BEFORE THE WELLINGTON CITY COUNCIL

IN THE MATTER Resource Consent Application 513399,
New Zealand Fruitgrowers' Charitable
Trust, To erect an electronic billboard to
the existing framework on the roof of the
building

Statement of Evidence of Jos Coolen

29 November 2022

Figure 4: (Photo - taken 24 November 2.50pm - of the wall art that has replaced previous signage on 86 Customhouse Quay)

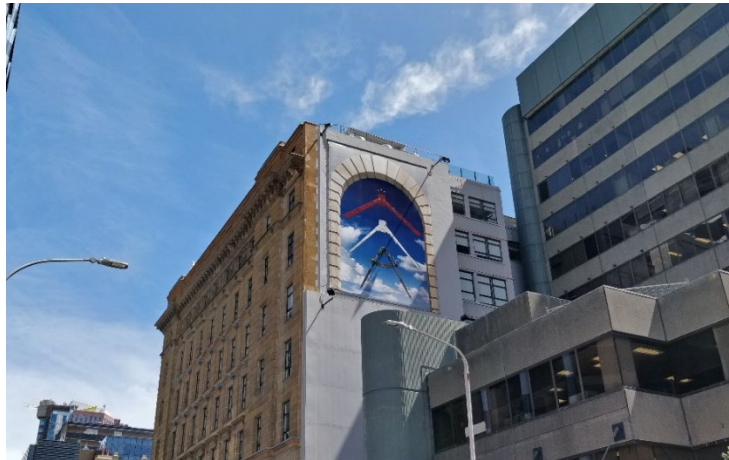
- 4.8 In the Section 42A report, (point 9 of the Site Description and Context section on page 2), it is noted that there is currently a billboard attached to the building at 86 Customhouse Quay. I note that this information (as well as the Google Streetview screenshot that was provided in the report) is out of date and that this billboard has for some time been replaced by static wall art. As can be seen in the photo below (Figure 4), the current wall art in this location is designed to match the buildings character by including an arch made out of large building blocks similar to that of the building's façade. Also the artwork uses a blue sky with clouds that ensures that the wall art comfortably blends in with its environment. I do not consider this wall art to be similar to the effects that any commercial signage can have on its surroundings.

Figure 5: Diagram of the Huddart Parker Building illustrating the Chicago Style, with proposed digital billboard highlighted above the top

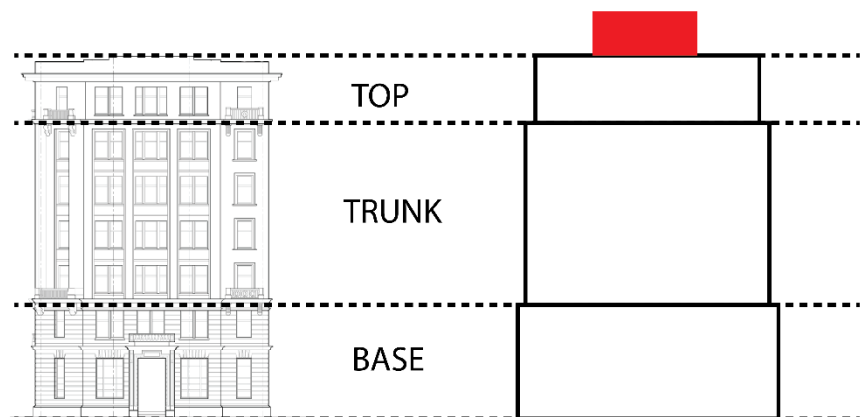
- 5.2 I concur with the concluding assessment of Ms Duffell (Conclusion of Urban Design Assessment, page 7, Appendix 4 of the Council's Section 42A Report) that the proposed billboard does not create a relationship with the architectural style of the billboard and would result in a distracting element to the character of the building.
- 5.3 The character of the Huddart Parker Building is defined by the building structure that is typical of the Chicago Style: a base, a trunk and a top, as indicated in Figure 5 below. I consider that the installation of the proposed digital billboard on the roof is incompatible with this building structure and overall architectural style of the building.

Figure 11: Photo showing visibility of existing framework (Photo taken on 8 November 2022 12.11pm)

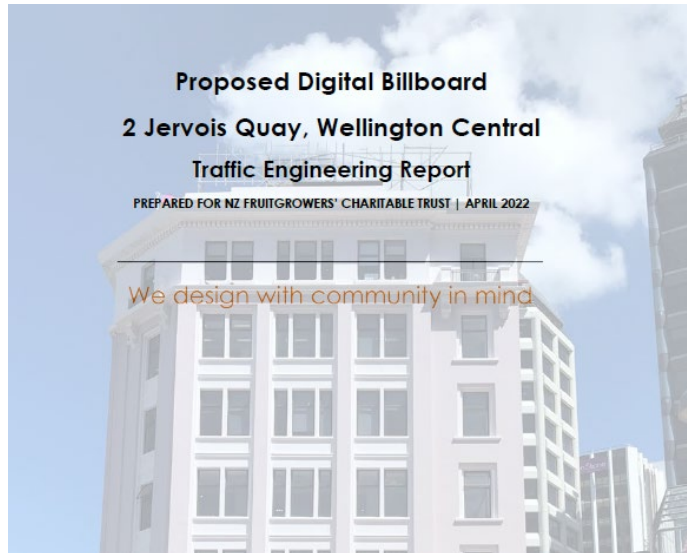
- 6.6 I disagree with the statement made by Mr Knott in his urban design evidence (paragraph 8.4 – 21D.3.1.11) that the proposed billboard will be ‘viewed against a backdrop of large buildings, and that clear views of it are not available from locations in close proximity’. While I agree this may be the case when viewing the building from a distance when approaching from the north via Customhouse Quay, this is not the case when viewing the building from a closer distance as can be seen below in the screenshots taken from the cover page of the applicant’s Traffic Engineering Report (Figure 9) and the applicant’s heritage assessment (Figure 10). This can also be seen in the photograph of the building and existing framework below (Figure 11), which was recently taken from the footpath leading to the building, along Jervois Quay.

Figure 12: Markup of the approximate areas from where the proposed billboard will be visible against a sky or against a backdrop of buildings. (Markups based on a walk around the Square on 29 November 2022)

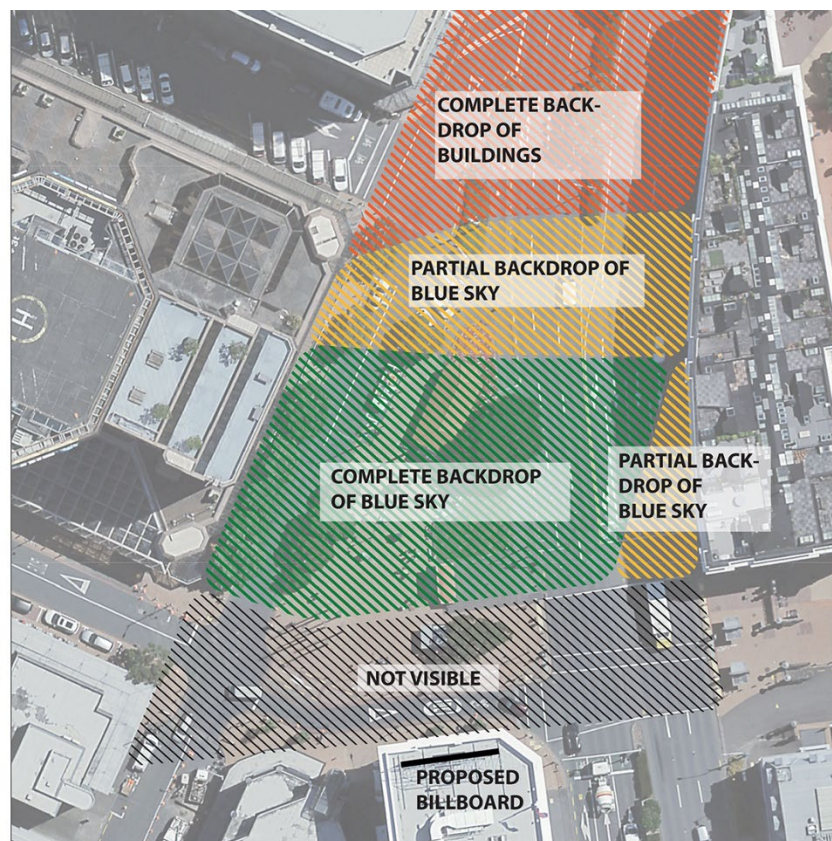
The current framework is visible against a backdrop of clear sky from the majority of Post Office Square as illustrated in green in the marked up plan in Figure 12 below. The yellow area illustrates the approximate locations from which the proposed billboard will be visible partly against a backdrop of sky and partly a backdrop of buildings. The amber area indicates the approximate areas of which the proposed billboard will be visible against a backdrop of buildings. These approximate markups have been determined by marking up an aerial while walking around the Square on 29 November 2022.

- 6.7 A billboard typically is designed to be seen and to be visible from its surroundings. A digital billboard that is viewed against a clear sky has a higher visual dominance than a billboard against a backdrop of buildings, particularly in the evening when office lights and other signage contribute to visual clutter.

Figure 13: A collage of existing signage on or near rooftops of buildings in the immediate surrounding of the Huddart Parker Building. (Photos taken on 29 November 2022)

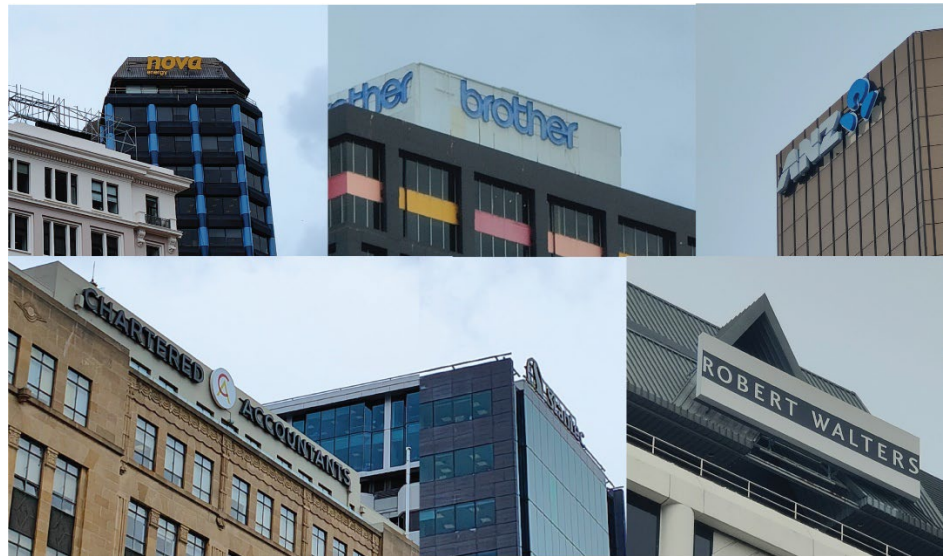
- 6.10 From a longer distance, I consider that the proposed billboard will add a contrasting element to the wider cityscape. There are a number of notable buildings in the immediate surroundings of the Huddart Parker Building that have static and partly permeable signage on or near the roof tops, as illustrated by the examples in Figure 13 below of signage in the immediate surroundings of the Huddart Parker Building. A digital billboard that consists of transitional and commercial content, that is not associated with the building itself, would result in a contrasting and visually dominant element in the wider cityscape view of buildings along the
